06/01670/ADV

16 NO. DOUBLE SIDED BANNERS FIXED TO LIGHT COLUMNS

AT Light Columns Between Silbury Boulevard And Avebury Boulevard Along, Witan Gate, Central Milton Keynes

FOR Milton Keynes Council

AMENDED PLANS

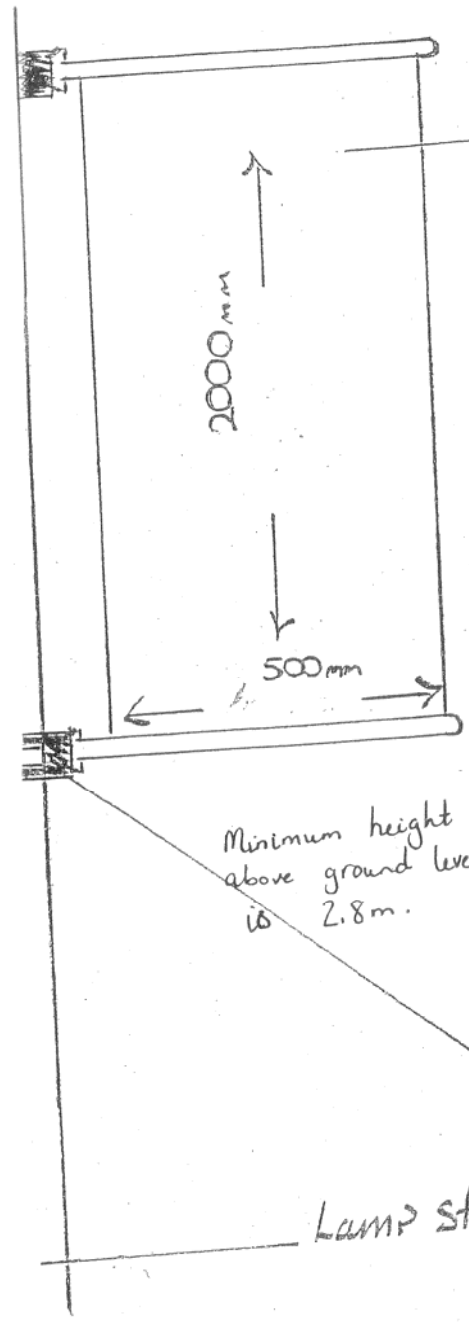
The Engineer (Highways Development Control), commenting on the application as originally submitted, advised that no banners should be erected on the two nearest (in direction of travel) lampposts to the junctions of Witan Gate with the Boulevards. The Engineer also advised that the banners should be a minimum of 2.8m above ground level.

The Crime Prevention Design Advisor for Thames Valley Police, commenting on the application as originally submitted, objected to 4 banners that would restrict visibility from the Community Safety CCTV camera situated at the junction of Witan Gate and Midsummer Boulevard.

Minimum Clearance
0.3 m from the edge of
the carriageway.

Minimum height
above ground level
is 2.8m.

Following receipt of the comments from the Highway Engineer and Thames Valley Police, the application has been amended to overcome their objections to the original scheme. The banners that would have been sited too close to the main junctions or would have obscured the view from the nearby CCTV camera have been omitted.
